STATE OF MAINE
DEPARTMENT OF TRANSPORTATION
16 STATE HOUSE STATION
AUGUSTA, MAINE 04333-0016

August 11, 2014
Subject: **Portland IMT**
State WIN: 022809.20
Amendment No. 3

DREDGE PILE STORAGE SKETCH

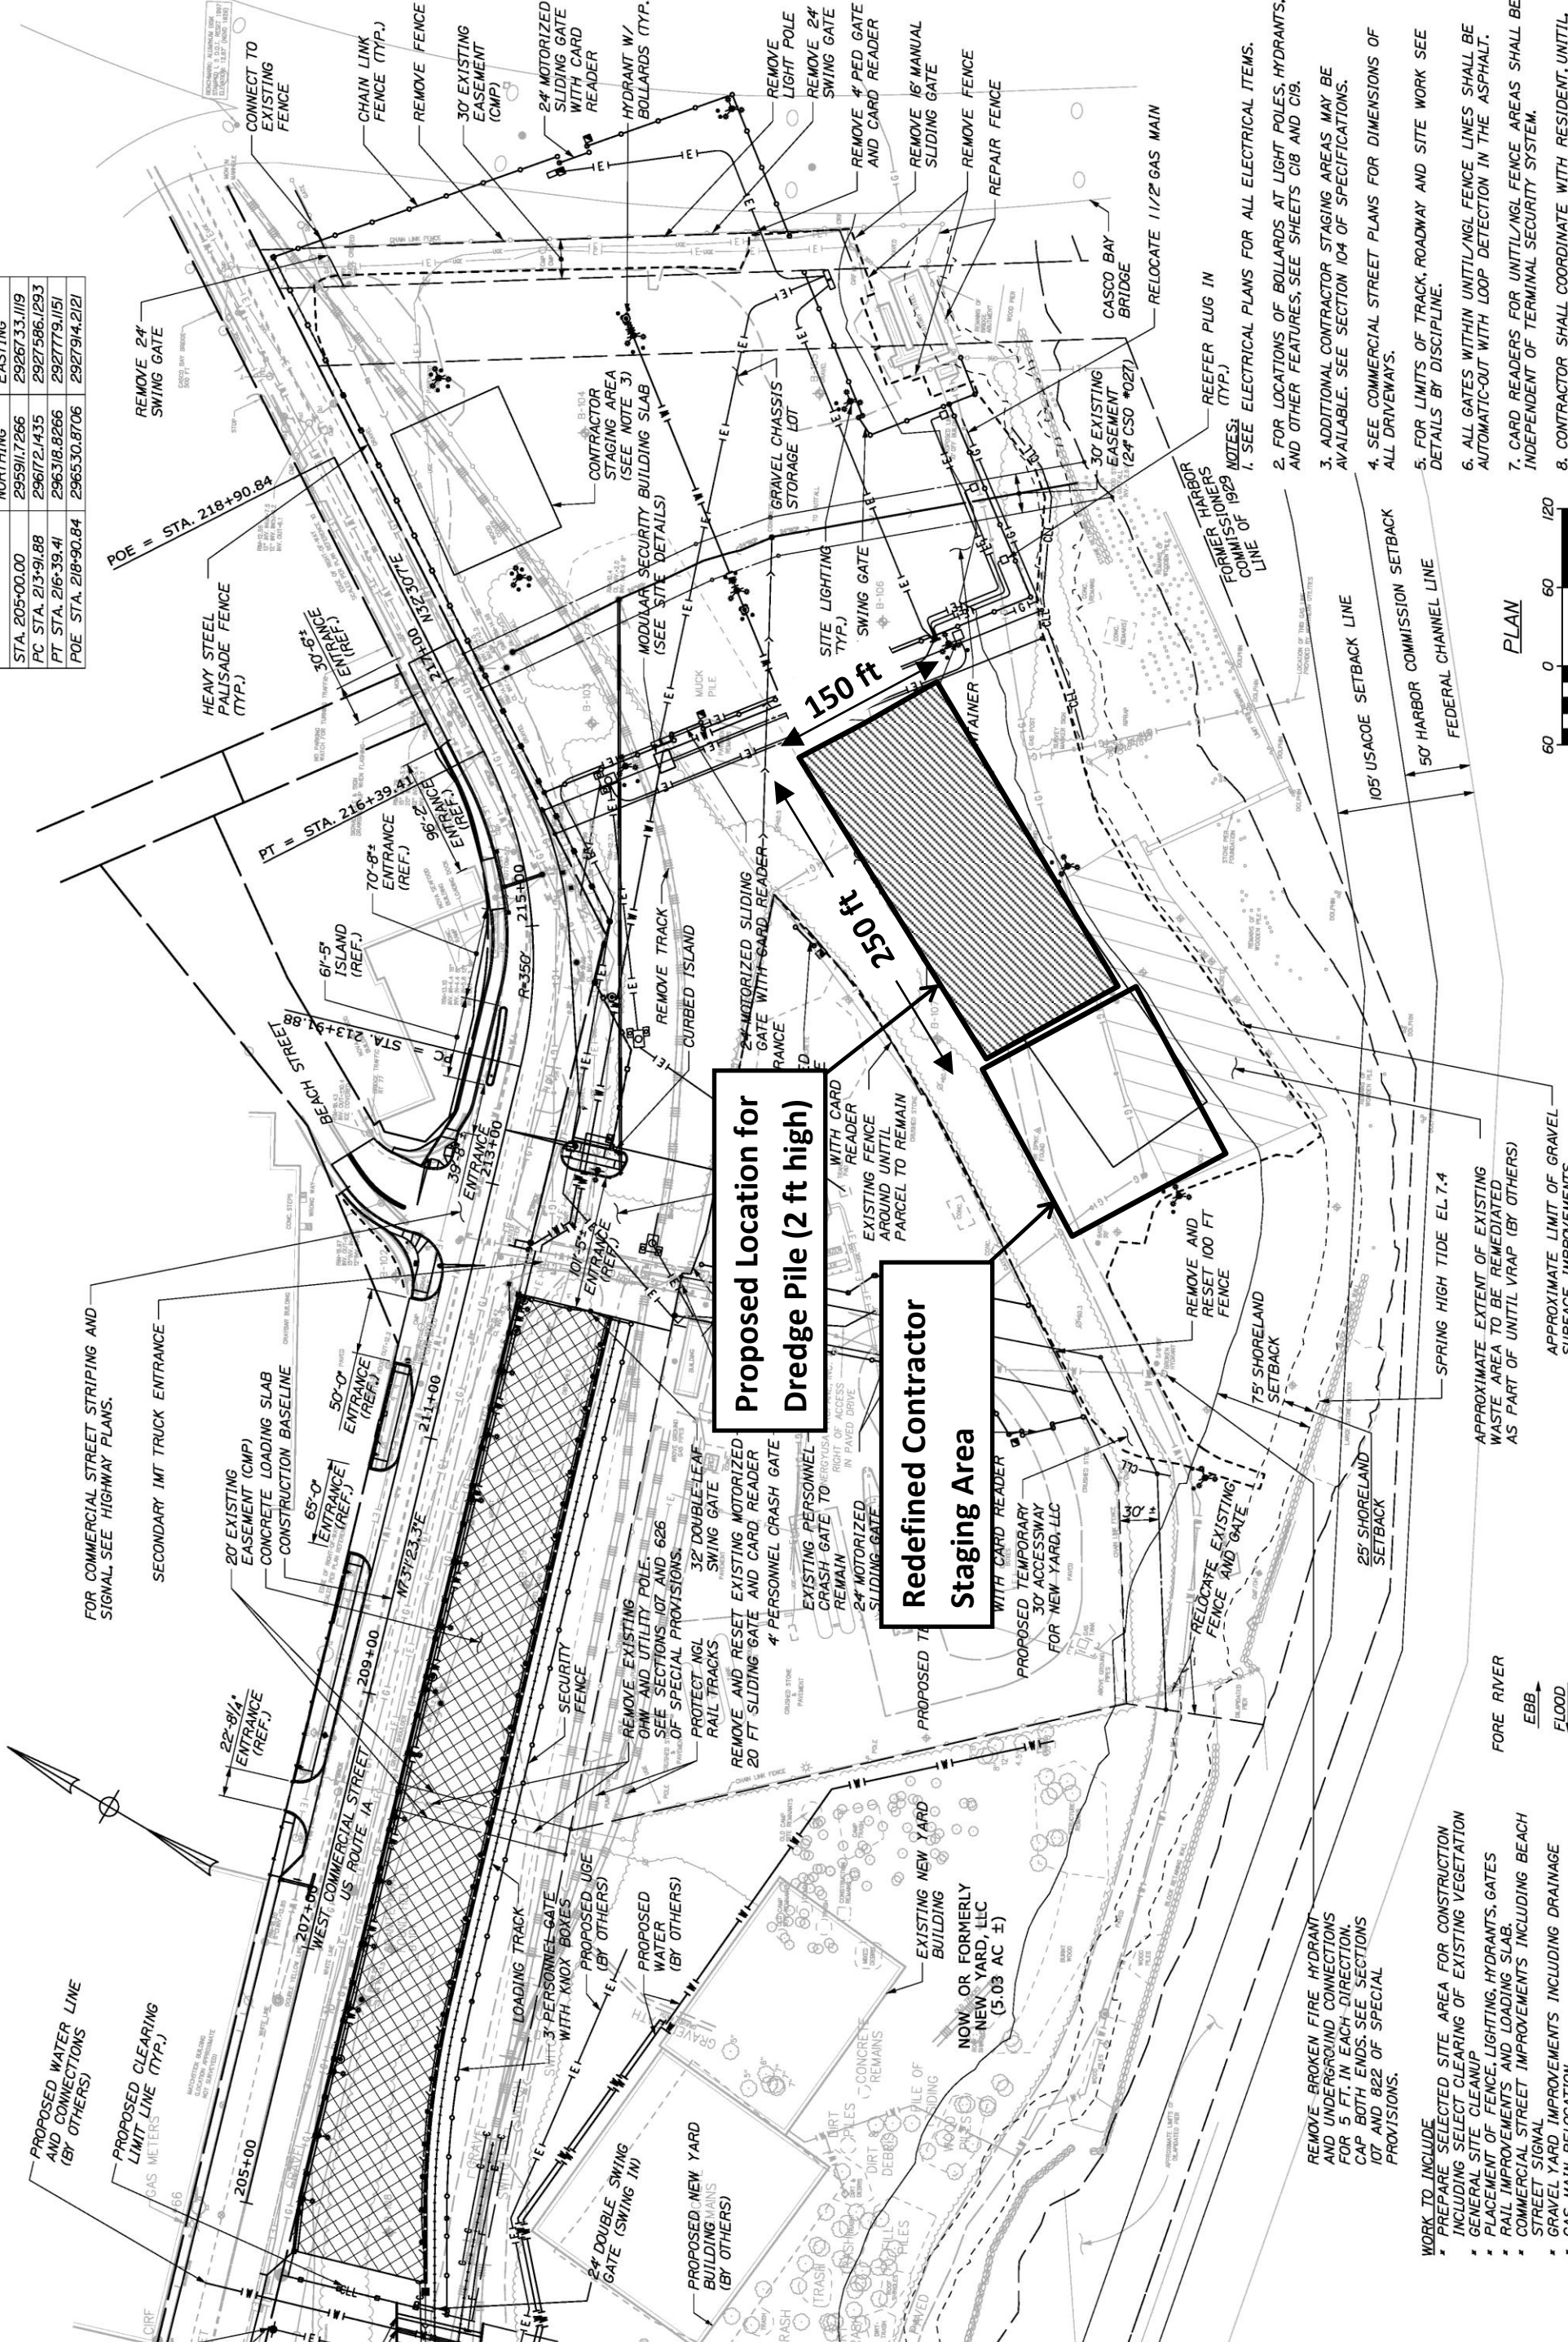
Add the attached Special Provision Section 203 Excavation and Embankment (Dredge Pile) one page, dated August 11, 2014.

Add the attached “Dredge Pile Storage Sketch”, one page total.

- Due to the uncertainty of final disposal of the existing dredge pile, and in order that the pile is moved to a designated area allowing development of the IMT site, the Contractor shall be responsible for moving the dredge pile en masse to the location and in compliance with the Dredge Pile Storage Sketch and Special Provision 203 Excavation and Embankment (Soil Management). Payment for excavation shall be made under Item 203.20 Common Excavation and shall include handling, moving, covering, and stabilization, of the dredge pile as shown in the plans and specifications. The Contractor shall account for relocation of the dredge pile in the project schedule and keep record to determine the amount of material excavated. Payment for separation and disposal of any timber waste shall be incidental to contract items and no additional compensation or payment shall be made.

- In the event that a changed location or disposal method is identified requiring the Contractor to conduct work in a manner other than stated above, all work including testing to relocate and/or dispose of the dredge pile in an approved manner and location, will be subject to and paid for on a Force Account basis as put forth in Maine Standard Specification, Section 109.7.5 Payment for separation and disposal of any timber waste shall be incidental to contract items and no additional compensation or payment shall be made.
